Get New Decal for Straight Scoop

FM 3-20.21 Note

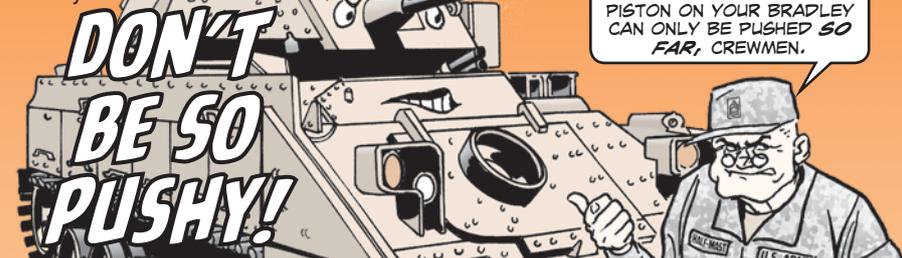
The main gun recoil piston sleeve position check starting on Page A-72 of FM 3-20.21 (Sep 09), *Heavy Brigade Combat Team (HBCT) Gunnery*, still contains the incorrect information on how to perform the GO/NO GO check. Until the FM is updated, do a pen and ink change. Change all **coax ammo feed chute** references in Step 4 to **breech block**.

Step 3 on the decal says to read the **top of the coax ammo feed chute** against the scale on the gauge. Problem is, warping and bending of the ammo feed chute can result in a bad measurement. So the procedure has been amended to read the **top of the breech-ring** against the gauge instead.

A new decal, NSN 7690-01-575-0788, is now available with the correct instructions. So strip off the old decal and apply the new, stick-on label in its place.
